**From:** City Planning <cityplanning@ccc.tas.gov.au>  
**Sent:** Thursday, 8 February 2024 4:59 PM  
**To:** TPC Enquiry  
**Cc:** O'Brien, Lauren; Planning; Mat Clark  
**Subject:** PDPSPAMEND-2021-019004 Combined Scheme Amendment & Draft Permit - 30 Holland Crt, Howrah - Response to TPC Directions

**Tasmanian Planning Scheme – Clarence**  
**Draft amendment PDPSPAMEND-2021-019004 and combined permit**  
**30 Holland Court, Howrah**

## **Attachment 1 : Response to Commission Directions of 27 September 2023**

Figure 1 - Ownership of Holland Court (Source LIST map)

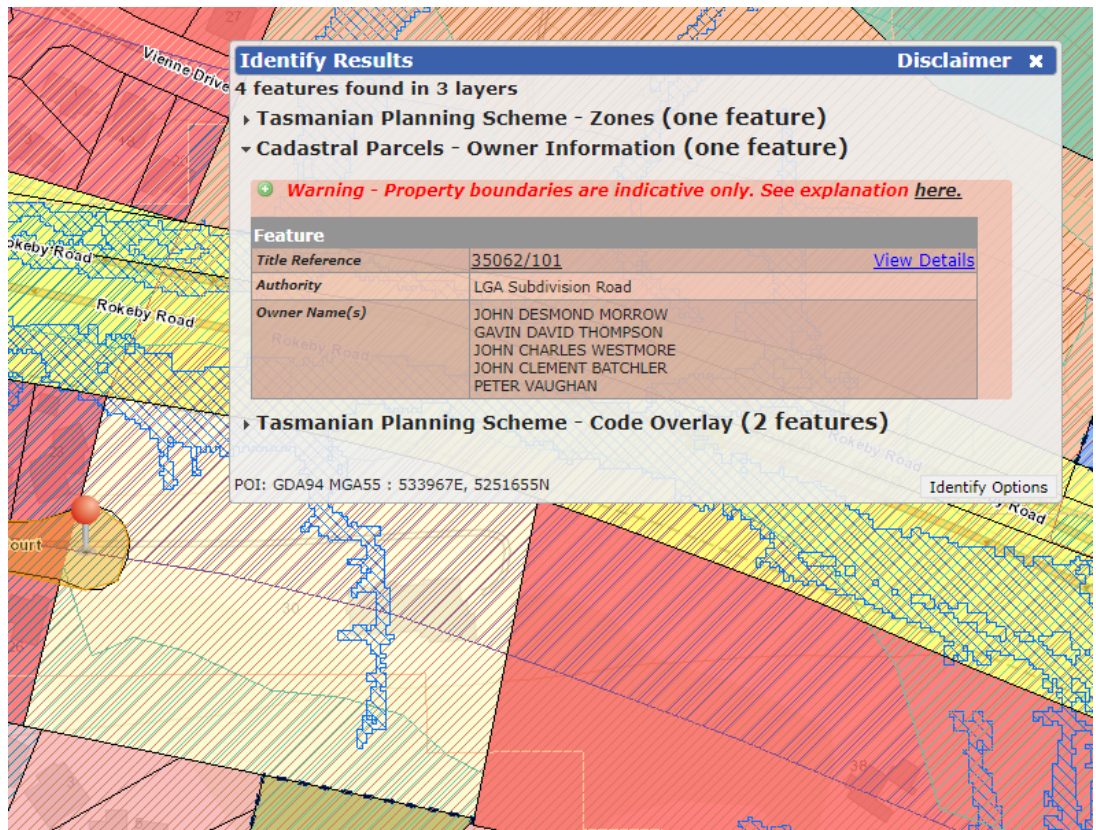
It appears that the road lot was never transferred into Council's ownership, and although Council has certain accountabilities as the relevant Road Authority, it is our understanding that this does not extend to the provision of landowner consent as per Section 37 (3) of the Act.

<b>Proposed Subdivision</b>	
Date: 10-8-2023	Reference: HOWCC01 12572-05
Scale: 1:500 (A3)	Municipality: CLARENCE

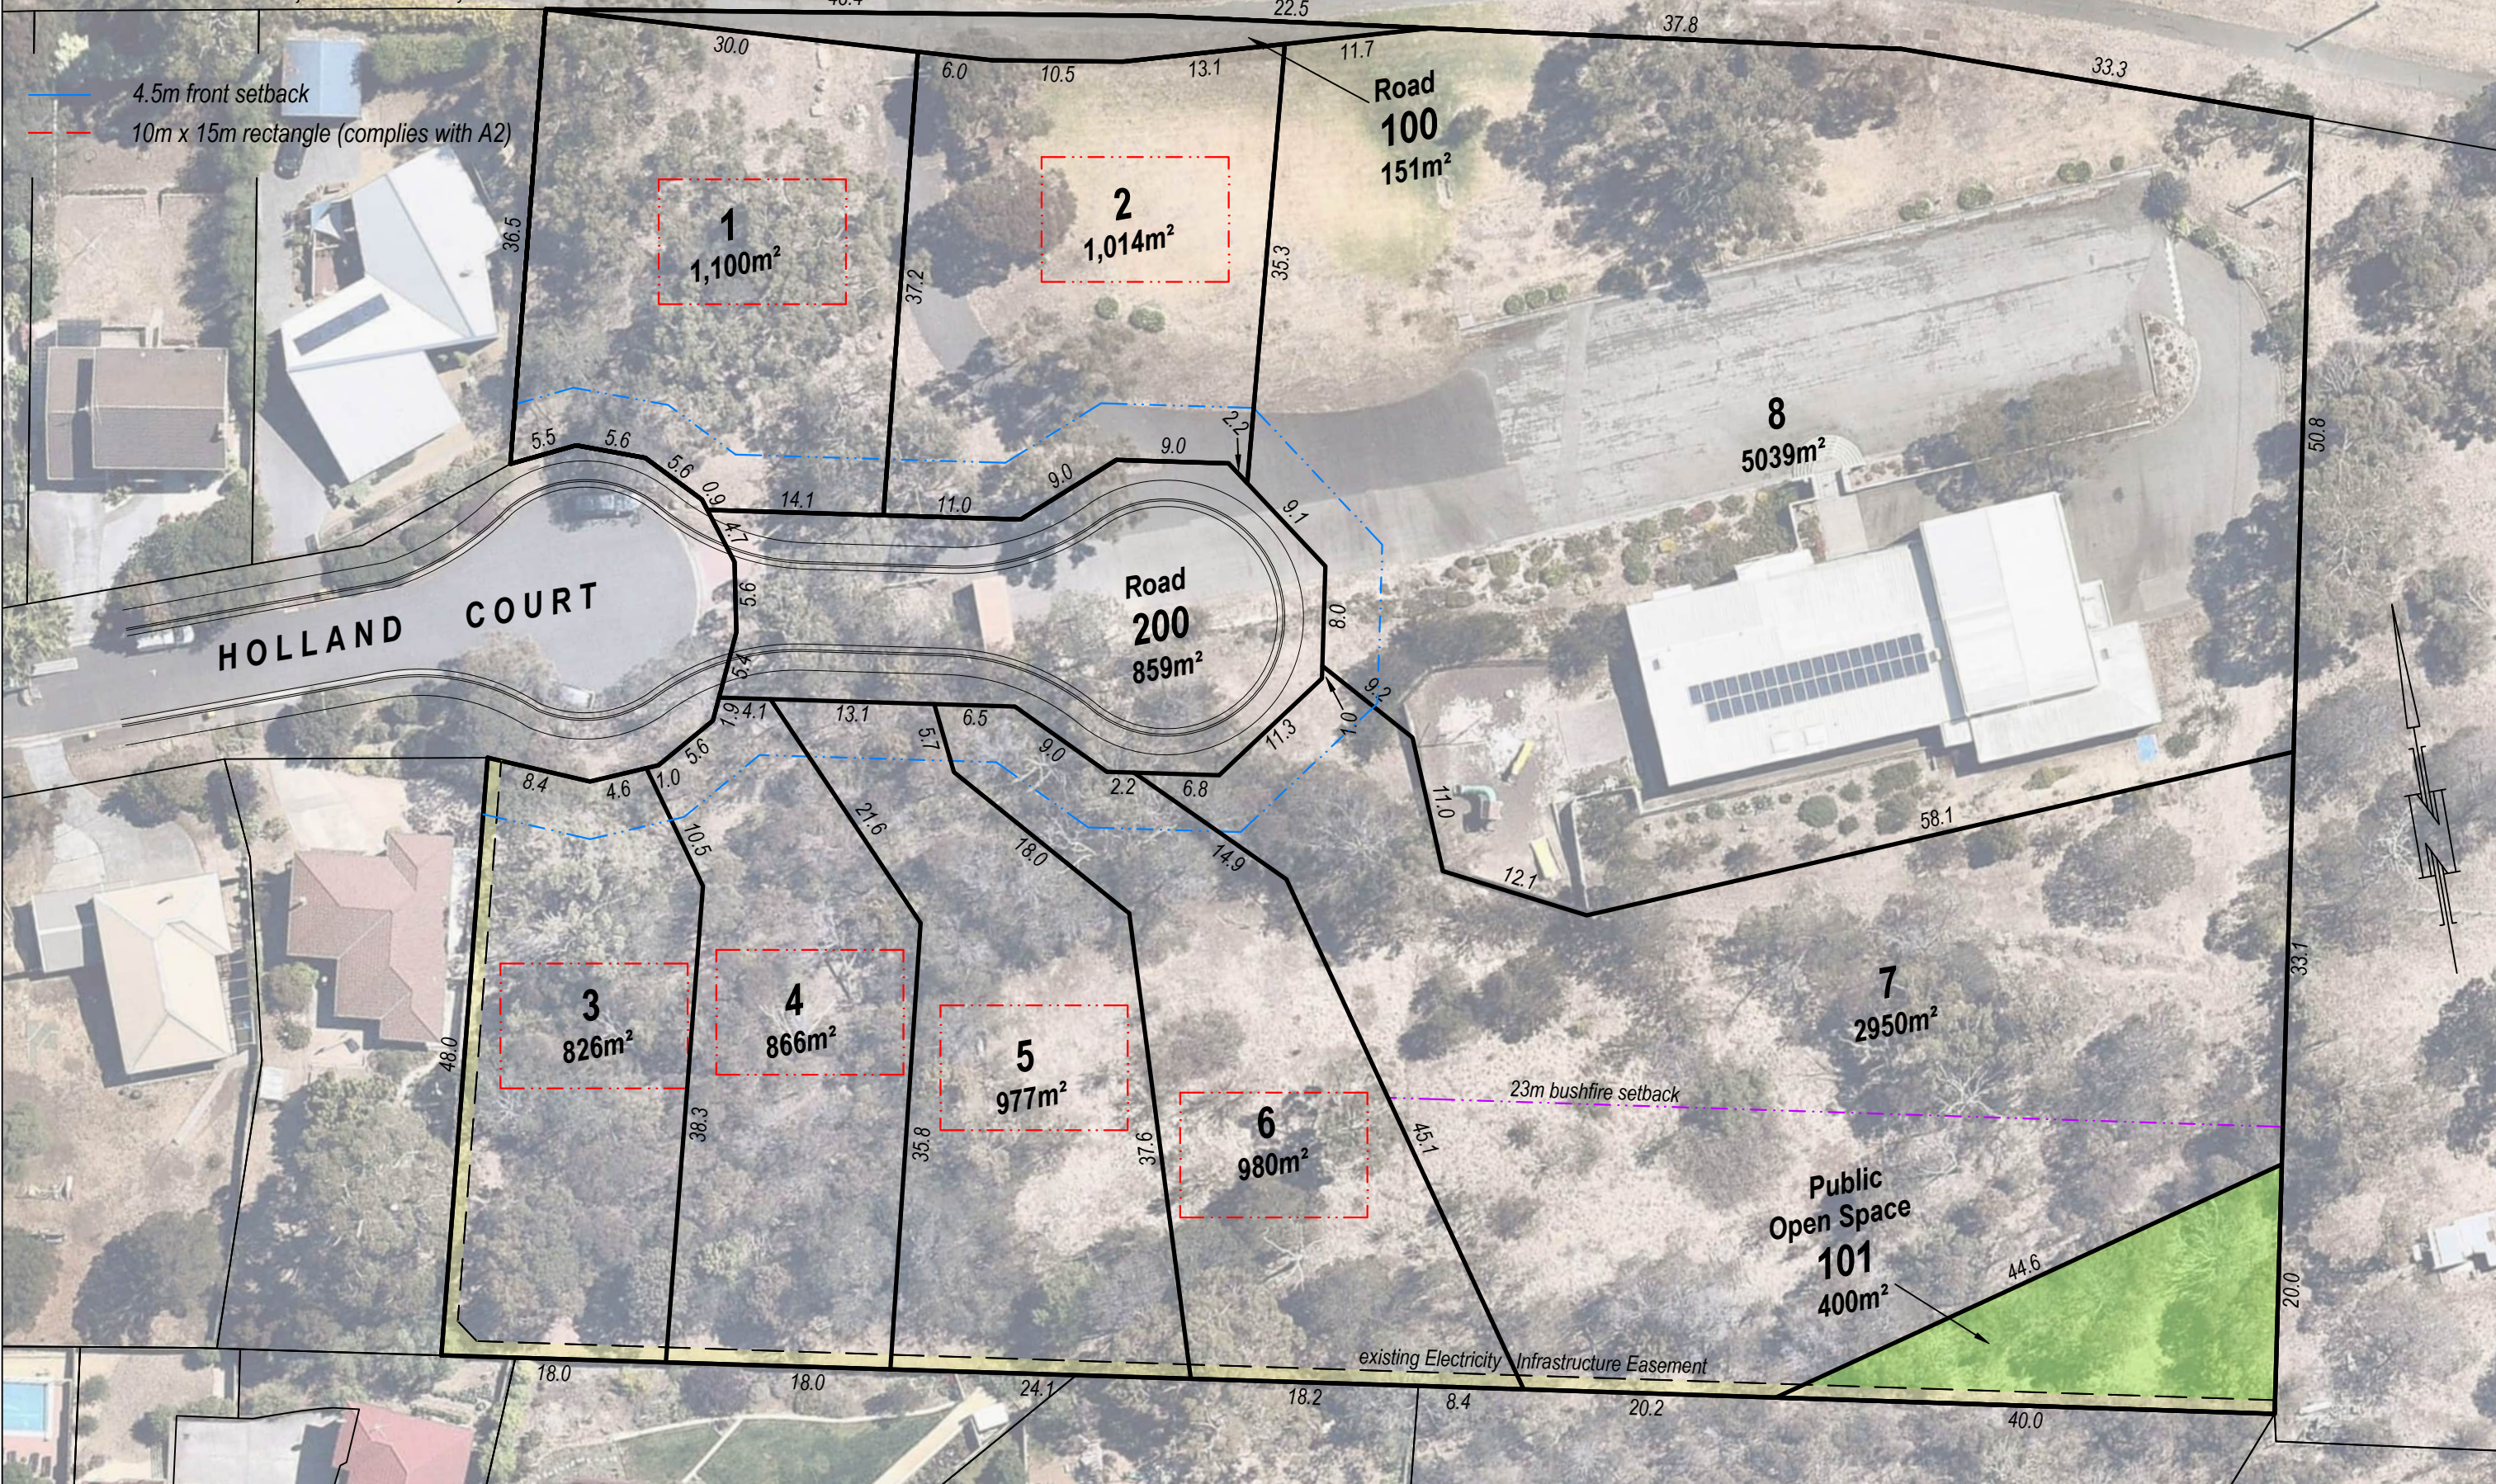
It is noted that the applicant submitted subdivision plan (Attachment 2 – Attachment 1 - Appendix A) differs from the council approved modified subdivision plan of 26 June 2023, as follows:

- Lot 1 area shown as 1,100m<sup>2</sup> in lieu of 899m<sup>2</sup>,
- Lot 2 area shown as 1,014m<sup>2</sup> in lieu of 792m<sup>2</sup>,
- Lot 101 area shown as 400m<sup>2</sup> in lieu of 754m<sup>2</sup> (based on the alternative public open space plan negotiated with the applicant) and
- No building area shown on lot 7.

1) revised subdivision plan (Attachment 2 – Attachment 1 - Appendix A) showing:

d) all necessary changes to residential lot designs resulting from the TFS feedback to the BHM Plan and BHA report as detailed in Attachment 3A.

### **Bushfire Hazard Management Plan**

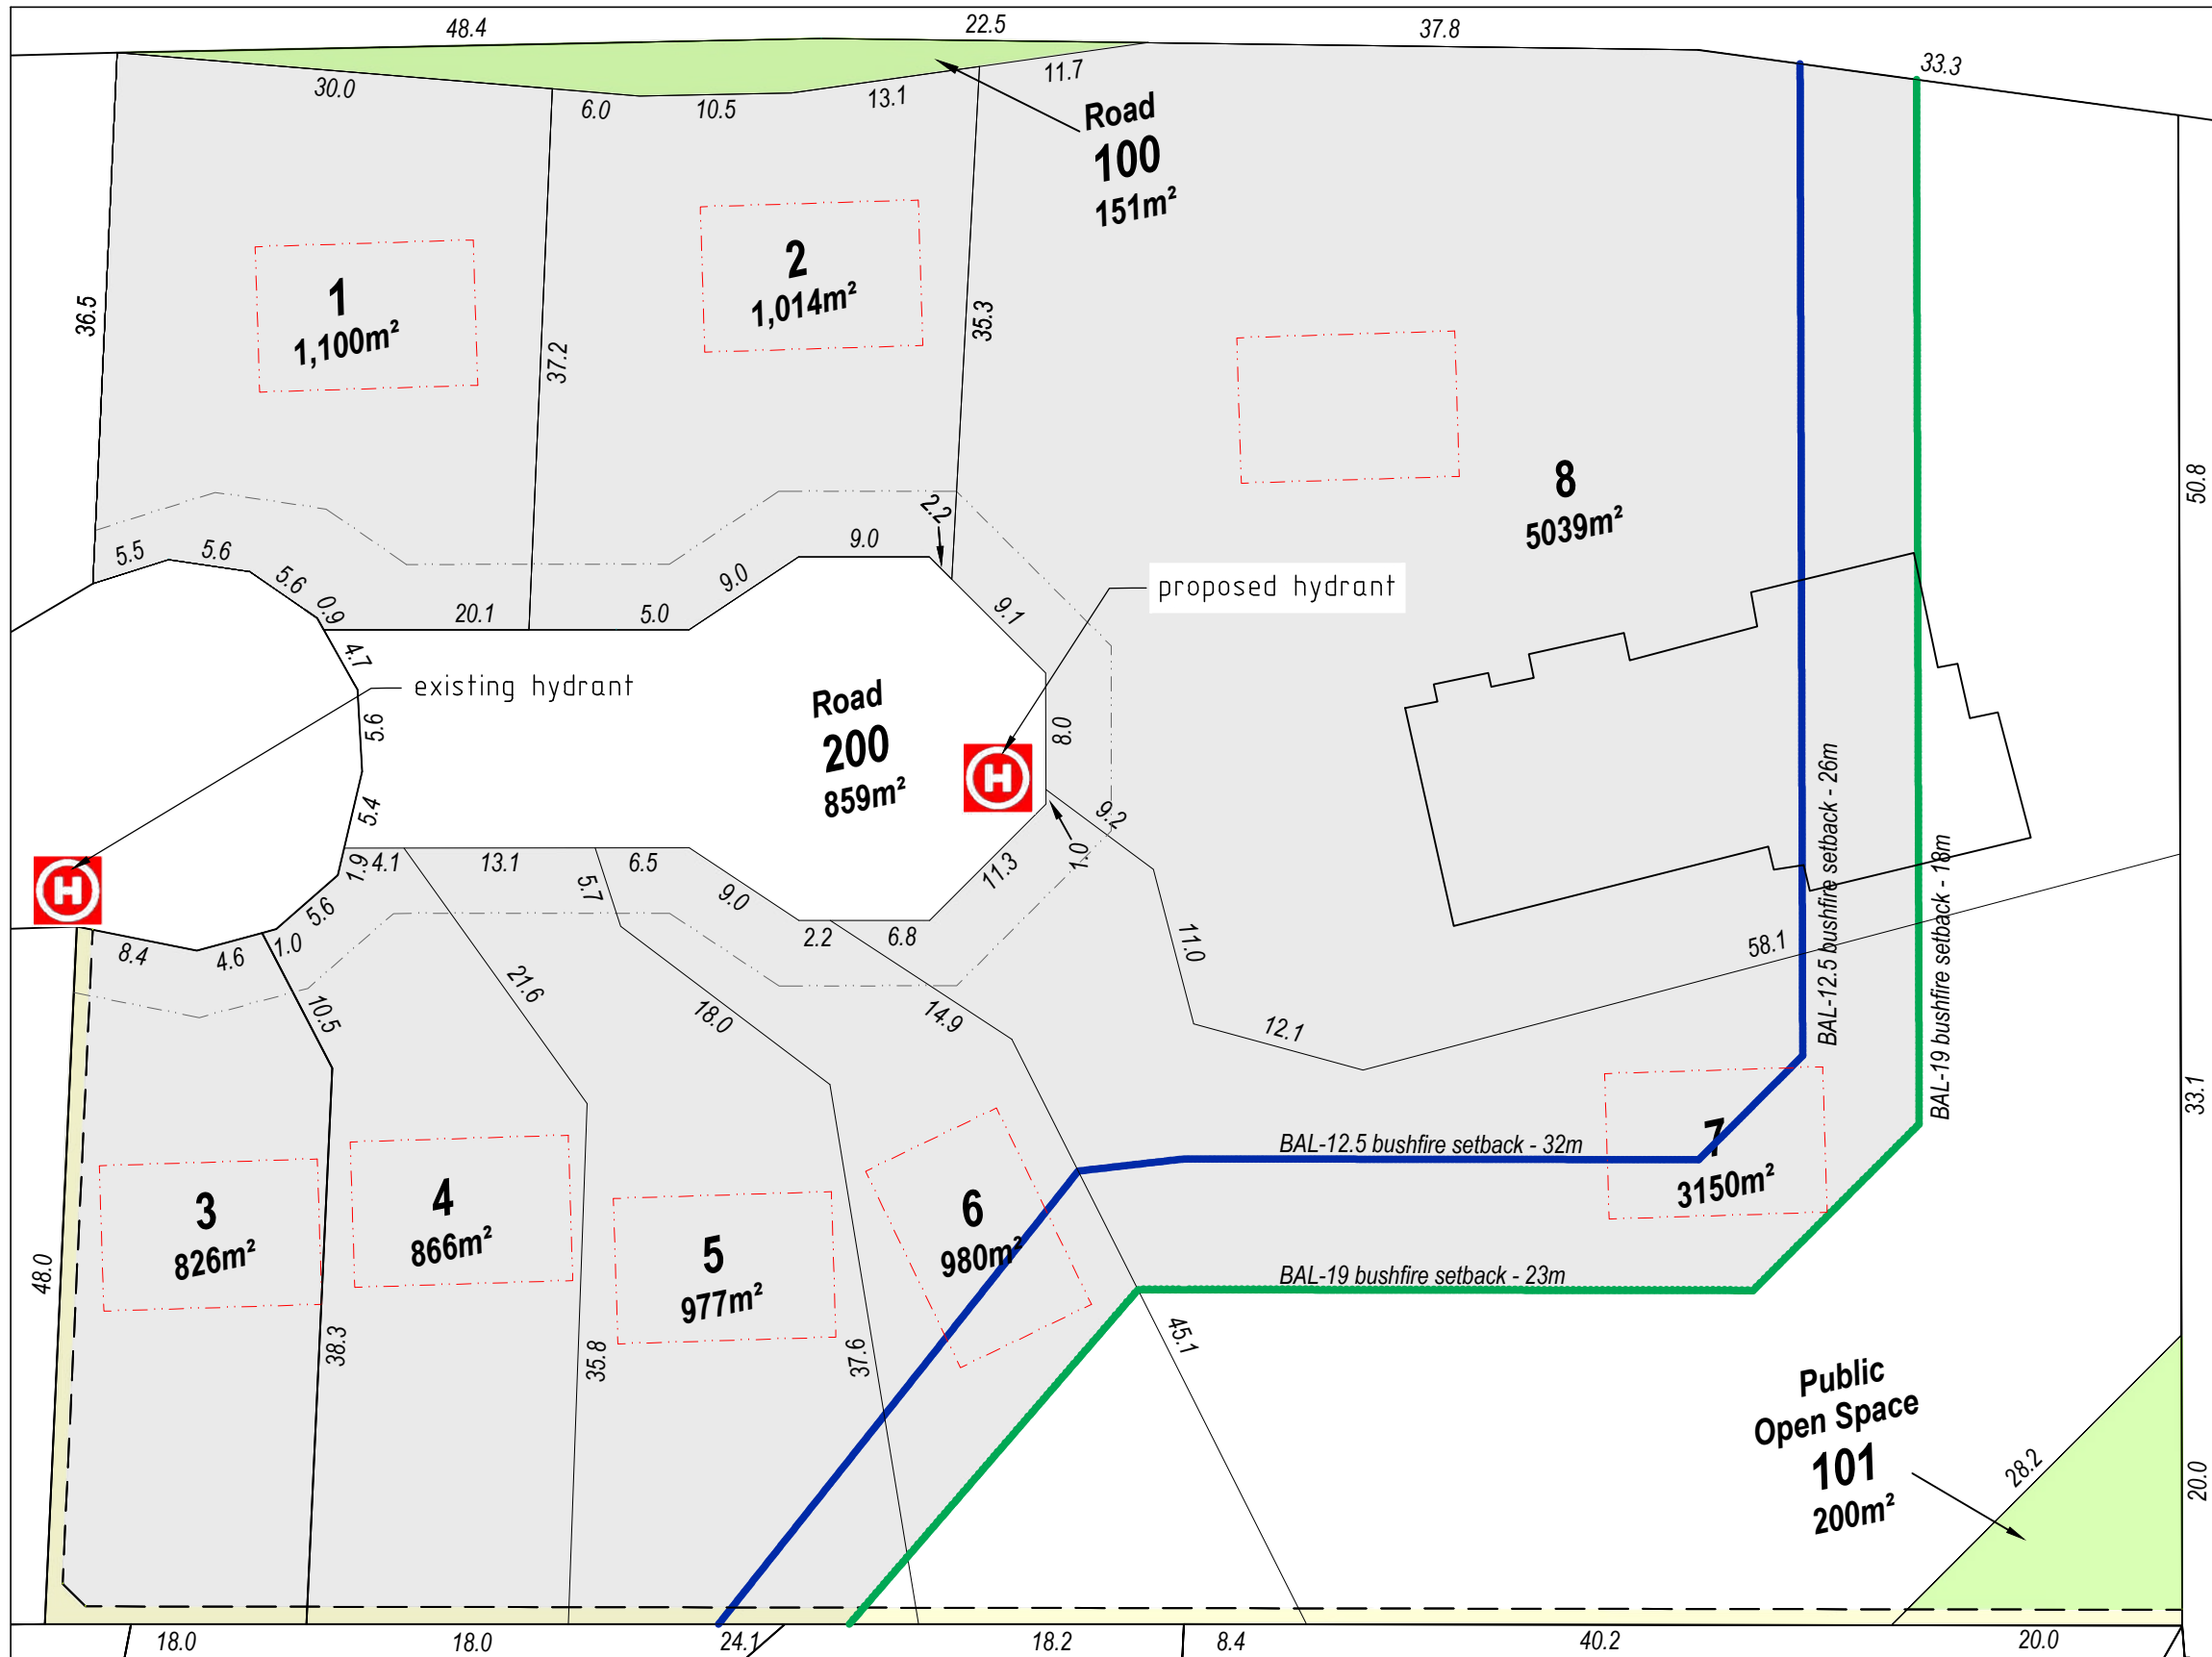
It is noted that the TFS feedback, requires updates to the BHM Plan, preferably prior to approval of the subdivision. Any updated BHM plan must show lot 101 (the open space lot in the south east corner), at the correct size of 754m<sup>2</sup>. The revised BHM Plan may require a redesign of the subdivision, in particular regarding lots 7 and 6, given the BAL-29 23m setback requirements. Therefore, it is not clear whether any revised subdivision plan would comply with the requirements of the scheme for lot design.

Furthermore, the BHM Plan submitted (Attachment 2 – Attachment 1 - Appendix B) shows lot 101 area as 200m<sup>2</sup> which is inconsistent with both the applicant submitted subdivision plan, and the Planning Authority supported modified subdivision plan of 26 June 2023.

2) revised BHA report and BHM plan responding to the TFS feedback and reflecting the changes identified in 1) above,
